Illinois Tollway Base Sheet Revisions

Section M Base Sheet Drawings		
Drawing	Modification Summary	Effective: 03-1-2020
<b>Roadway (RDY)-Series 400</b>		
<b>M-RDY-403 ROADWAY TYPICAL SECTIONS GROUP D</b>	Removed Topsoil line behind gutter details.	
<b>M-RDY-407 EARTHWORK SCHEDULE</b>	Incorporated new earthwork table from Design Bulletin 19-2. Updated notes to designer and removed tons conversion number.	
<b>M-RDY-408 APPROACH SLAB, MAINLINE, SHEET 1</b>	Added Sleeper Slab at the end of Transition Slabs. Modified the parapet joint call out to "1/2" CORK JT, TYP." Removed notes 7, 8, 9, 10, 13, and 18 from General Notes. Removed 'Note to Designer' about smoothness and grinding procedure.	
<b>M-RDY-408 APPROACH SLAB, MAINLINE, SHEET 2</b>	Added Sleeper Slab at the end of Transition Slabs. Modified the parapet joint call out to "1/2" CORK JT, TYP."	
<b>M-RDY-408 APPROACH SLAB, MAINLINE, SHEET 3</b>	Modified the parapet joint call out to "1/2" CORK JT". Removed cork joint callout from SECTION I-I and revised sketch to reflect aluminum joint full height. Added Sleeper slab at the end of Transition slab in the Longitudinal Cross Section. Included designer note to increase 1/4" for grindi

SHEET 1 OF 5  
BASE SHEET M-RDY-408

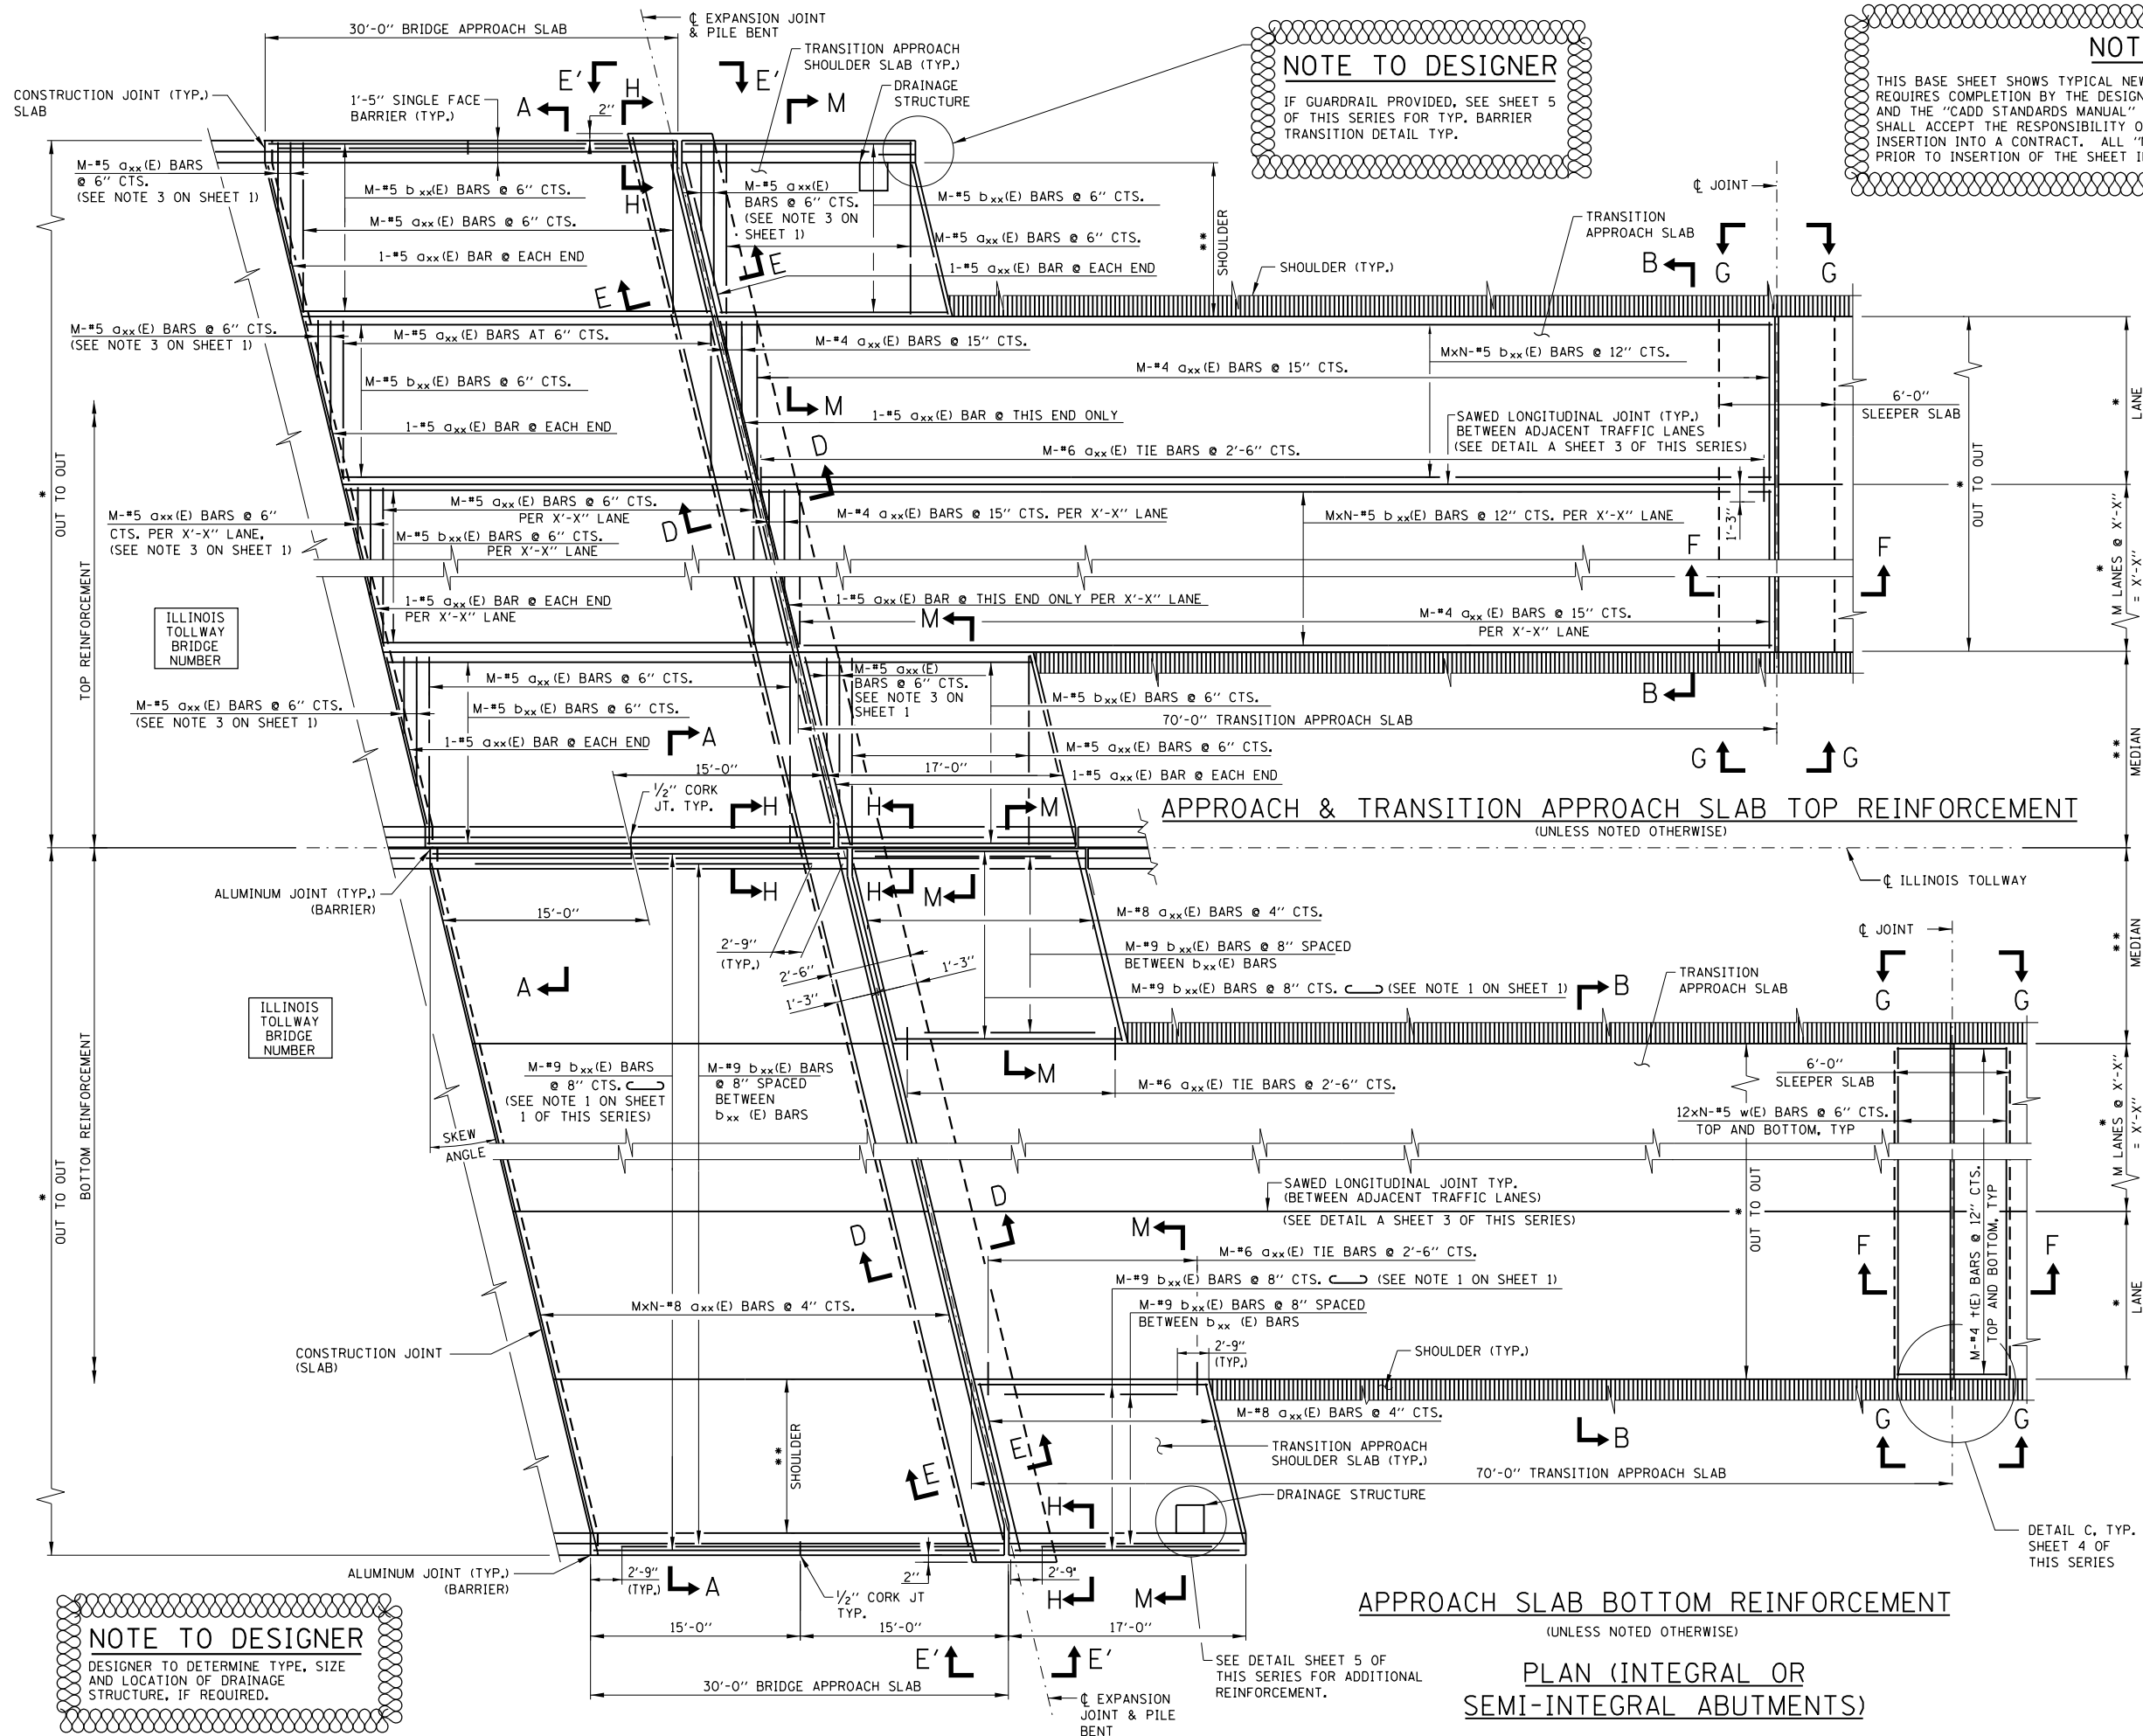
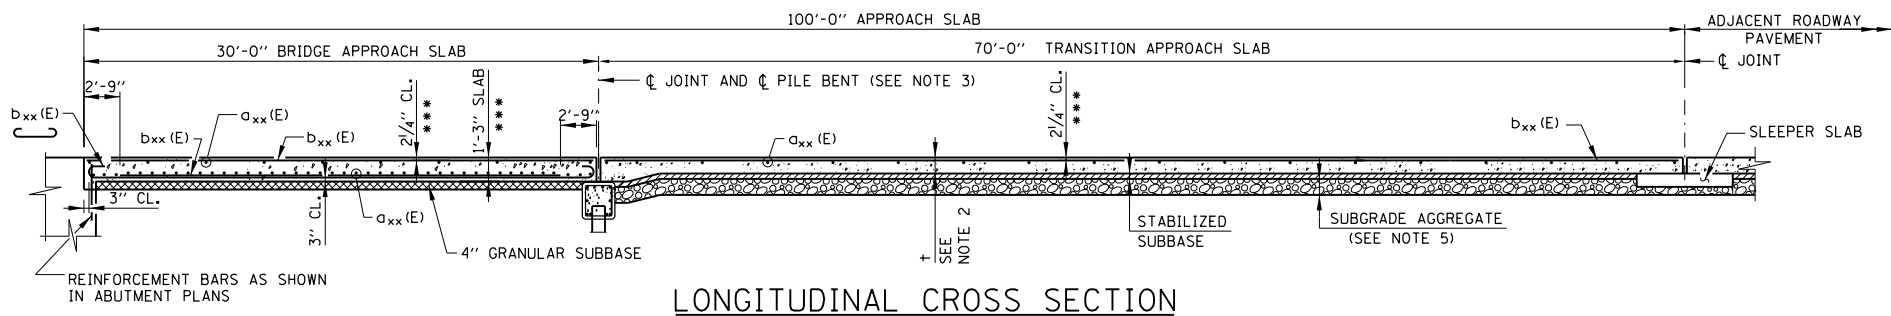
<b>M-RDY-408 APPROACH SLAB, MAINLINE, SHEET 4</b>	Added sleeper slab details in the section F-F. Included designer note to increase 1/4" for grinding.	
<b>M-RDY-408 APPROACH SLAB, MAINLINE, SHEET 5</b>	Added t(E) and w(E) bars in the Bill of Material. Modified pay item for Bonded Preformed Joint Seal and added a corresponding "Note to Designer". Included pay item for Sleeper Slab in the Bill of Material. Included designer note to increase 1/4" for grinding. Added pay items for Bridge Deck Grooving, Protective Coat and Grinding & Smoothness. Add notes to designers to clarify the limits to quantify grooving and grinding.	
<b>M-RDY-409 APPROACH SLAB, RAMP SHEET 1</b>	Added Sleeper Slab at the end of Transition Slab. Modified the parapet joint call out to "1/2" CORK JT, TYP." Removed notes 7, 8, 9, 10, 13, and 18 from General Notes. Removed 'Note to Designer' about smoothness and grinding procedure.
